OSU Canopy (HPP12-00029)

Corvallis Planning Division
Staff Report to the Historic Resources Commission
November 30, 2012

Request

Attachment C

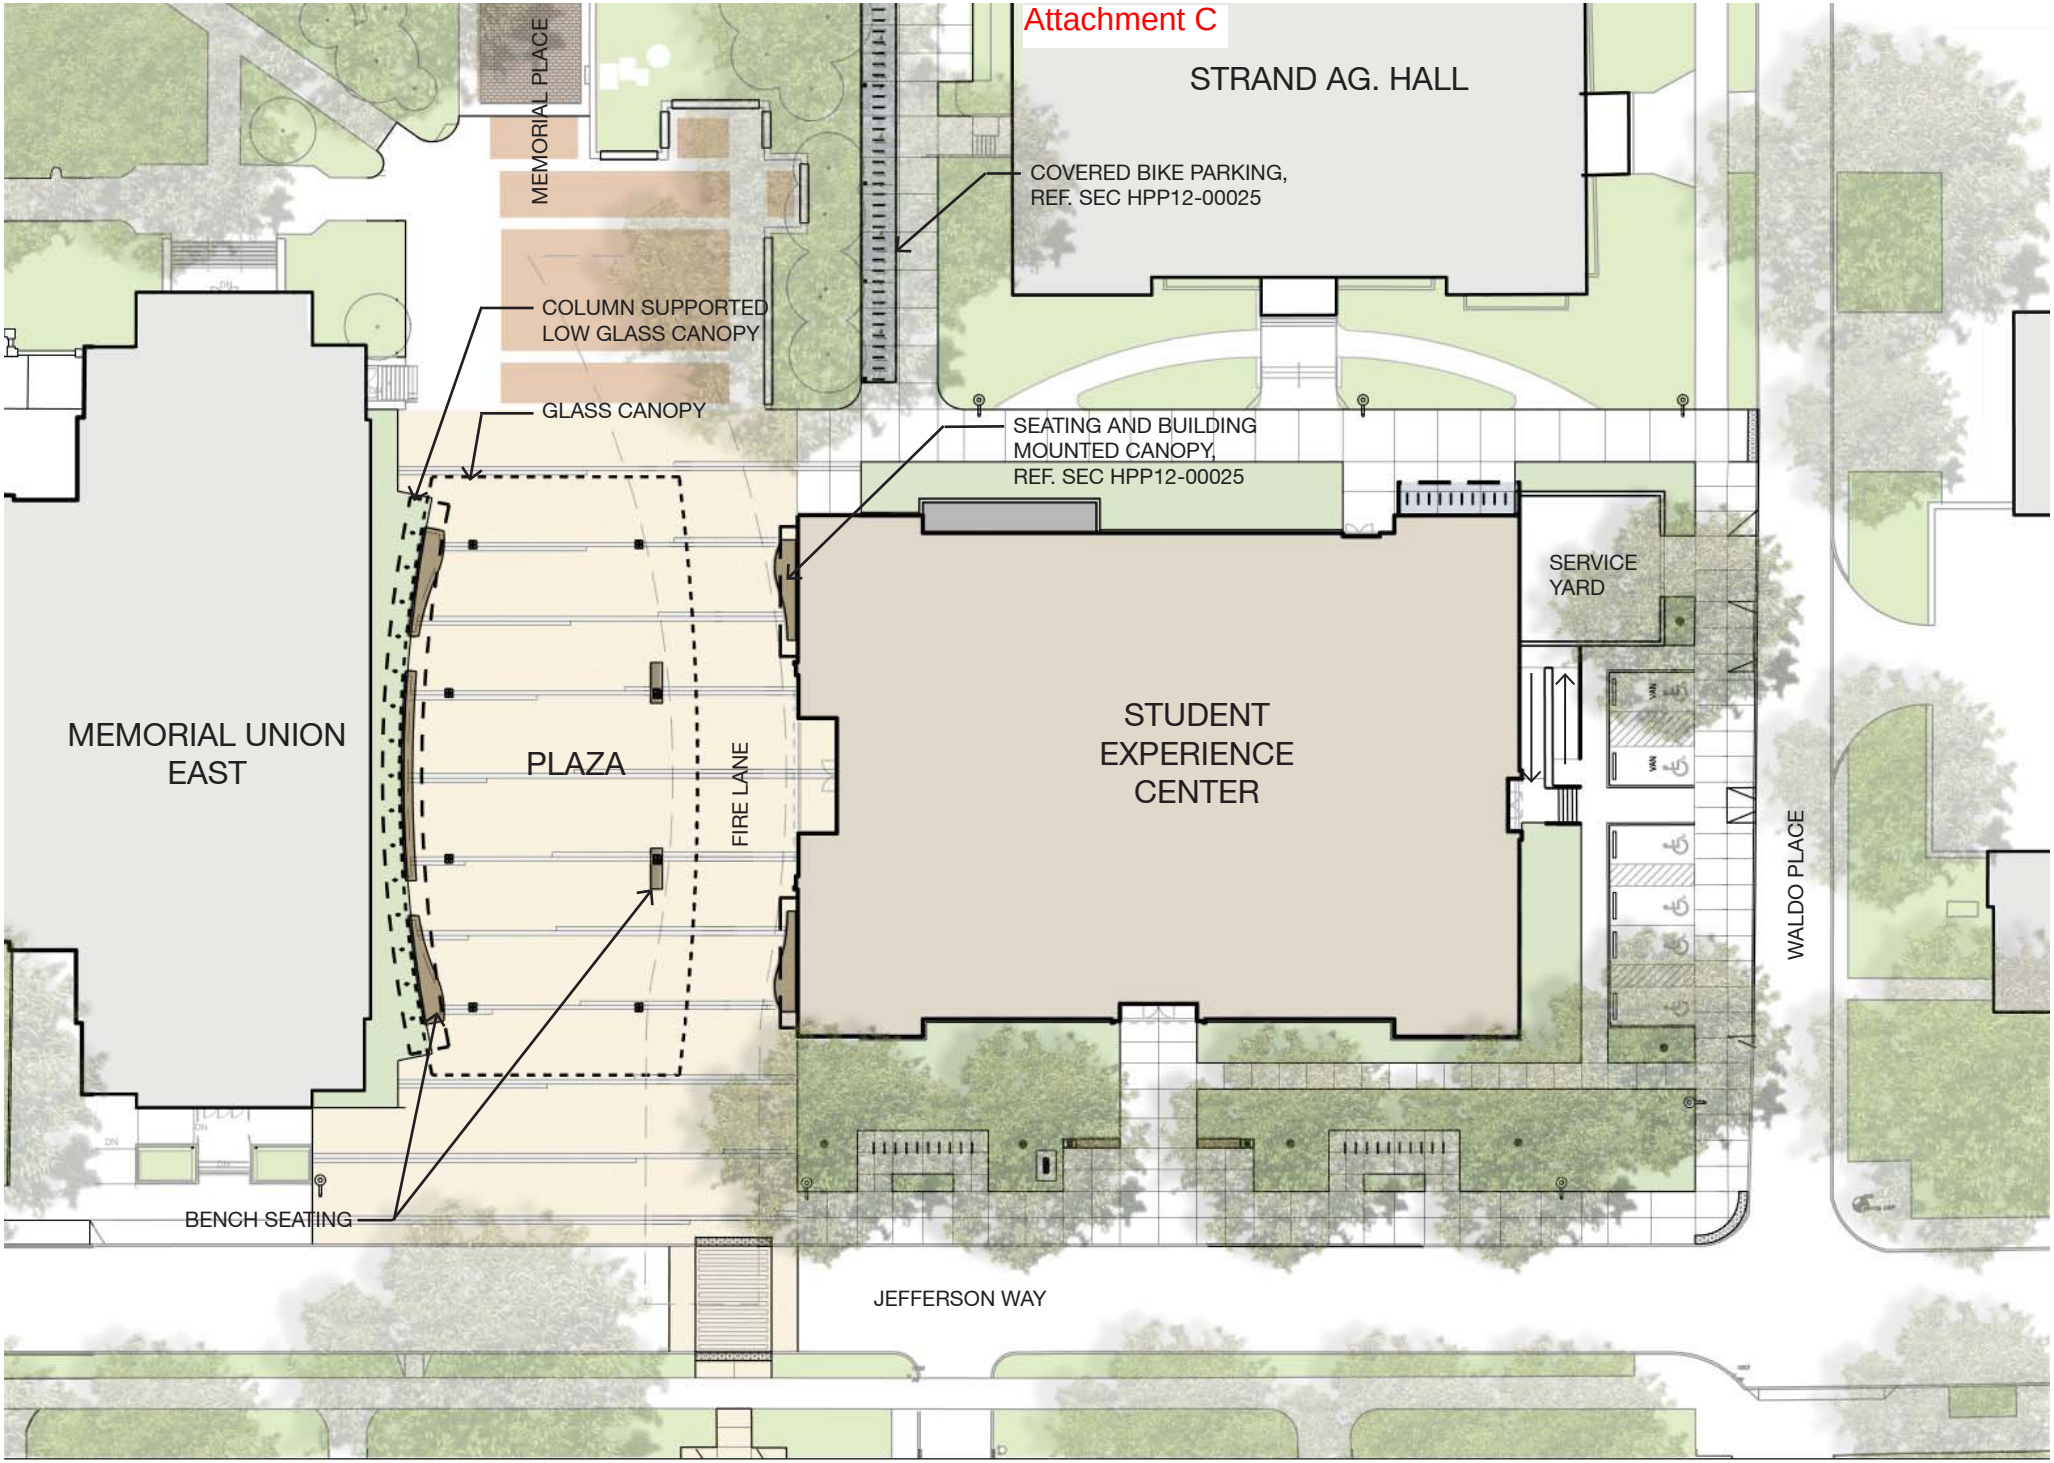
Land Development Code Chapter 4.0 – Improvements Required with Development, requires SW Jefferson Way to be improved to City standards, which requires at least a 5-ft wide sidewalk and a 6-ft wide planter strip. The applicant has shown two street configurations, one that satisfies current LDC standards, and one that is based on a standard that OSU plans to propose, but has not been yet been considered or approved by the City. **Condition of Approval 5** requires SW Jefferson Way to be configured as proposed in **Attachment A.12, or Attachment A.13**, if City Standards would permit the alternate design at the time of Building Permits.

5. **SW Jefferson Way Improvements** – SW Jefferson Way shall be improved to City standards for a local street with 6-ft wide landscape strips and 5-ft wide setback sidewalks (widths are minimums) in the area shown in **Attachments A.12 and A.13** of the November 30, 2012, HRC Staff Report. Alternatively, the street shall be configured as shown in **Attachment A.13** of the Staff Report, and constructed to the standards in place at the time of Building Permits, if the City of Corvallis adopts new street standards for Oregon State University that permit this configuration.

OSU CANOPY
TRANSVERSE SECTION LOOKING SOUTH
11.13.2012
OPSIS ARCHITECTURE

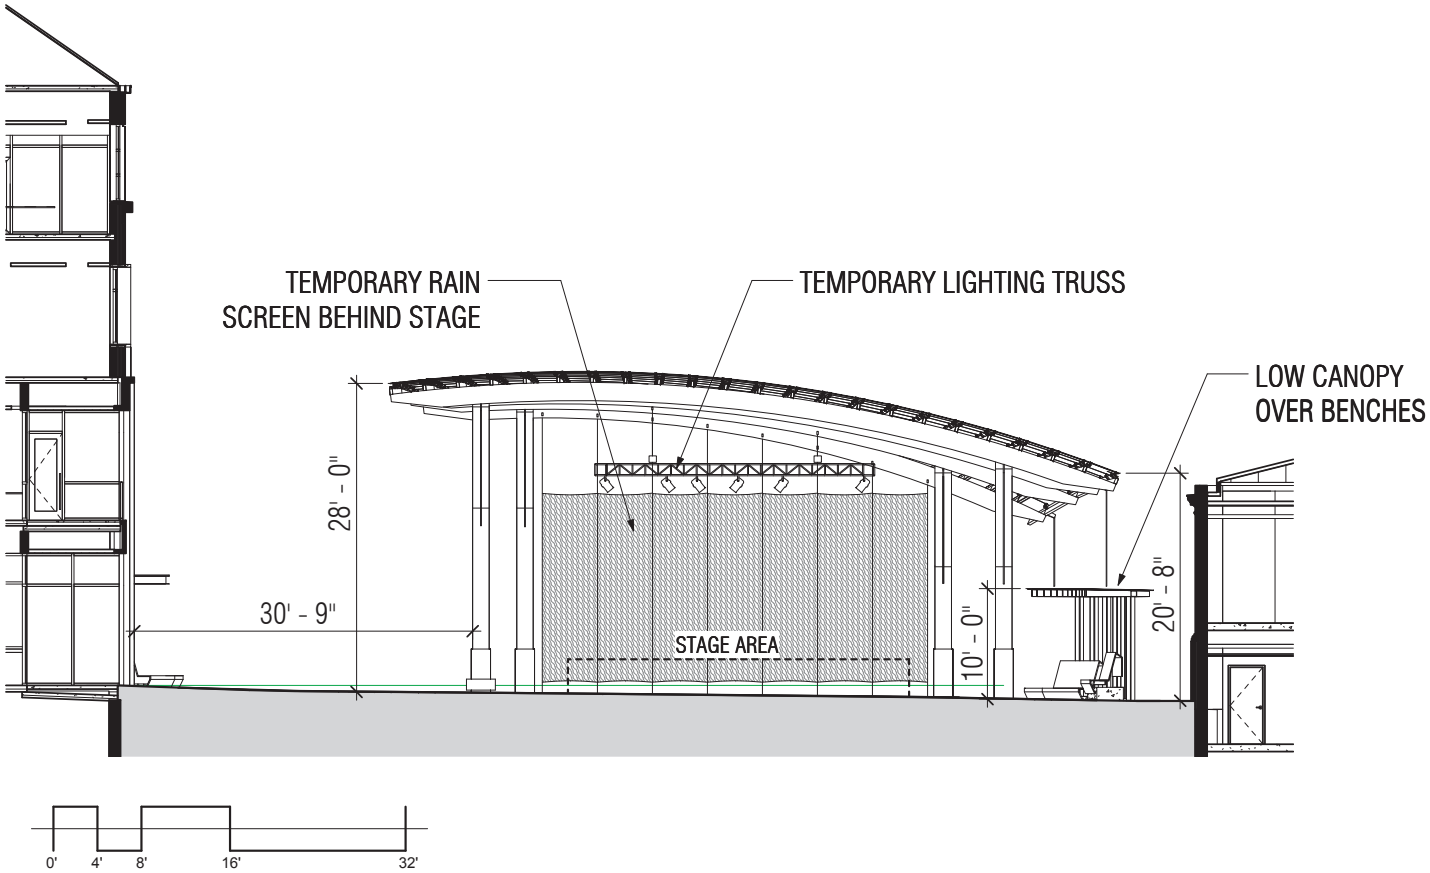
The canopy is approximately 57-ft wide and 137-ft long, covering an 8,000 sq. ft. area on the east side of the MU. The MU east wing is approximately 170-ft long, and the canopy is recessed from the south wall of the MU. The canopy has a curved roof that is 28-ft tall on it east edge, near the proposed SEC building, and 18-ft tall on its west edge, near the MU.

As shown in **Attachment A.15**, the canopy would be taller than the east wing of the MU, but the abutting west edge of the canopy roof would be approximately the same height as the east MU wing. Though the canopy would be taller than the east wing of the MU, it would not dominate or overshadow the MU **(Attachments A.17-19, 22)**. Additionally, the proposed SEC building is four stories tall, compared to the one story MU east wing. If both the canopy and SEC building are approved, the canopy would provide a height transition between the two buildings.

Attachment K

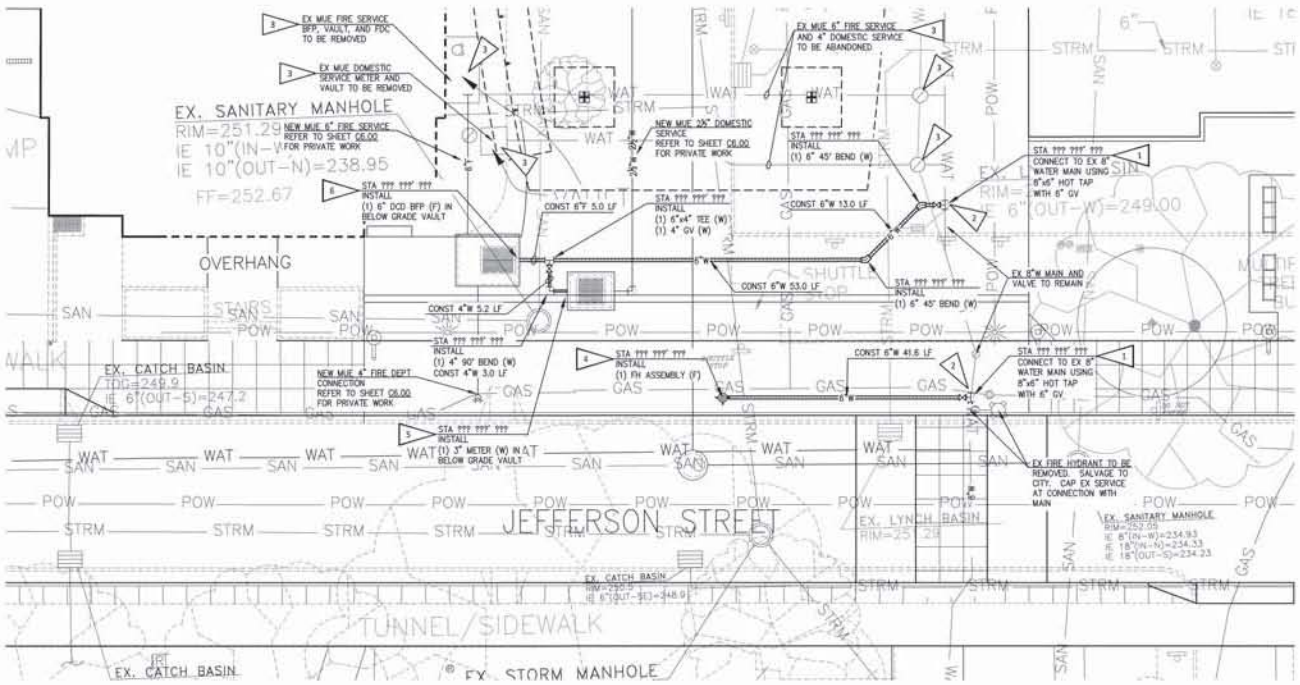
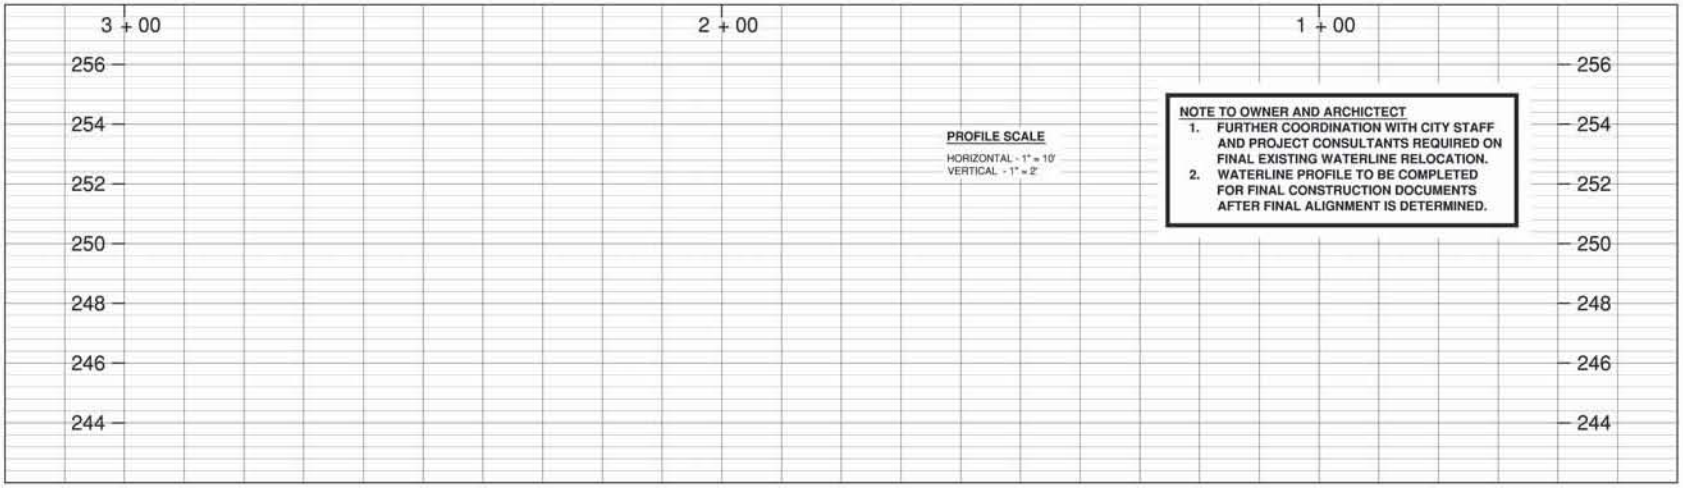
A second issue is that public waterlines and vaults in easements granted to the City are located in the area where the canopy is proposed **(Attachment A.26)**. Structures are not permitted to be placed over public utilities and utility easements. **Condition of Approval 3** requires the utility lines to be relocated prior to constructing the canopy.

3. **Public Utilities** – To construct the canopy as proposed, the applicant shall relocate the public waterlines. Public waterlines, fittings, valves, and meters shall be located a minimum of 7.5' (both sides) from buildings, footings, and canopy overhangs. This requirement is consistent with the City's easement for waterlines on campus that is 15' wide, centered on the pipe. Relocation of the waterlines will require a PIPC permit from the City of Corvallis, Public Works Engineering.
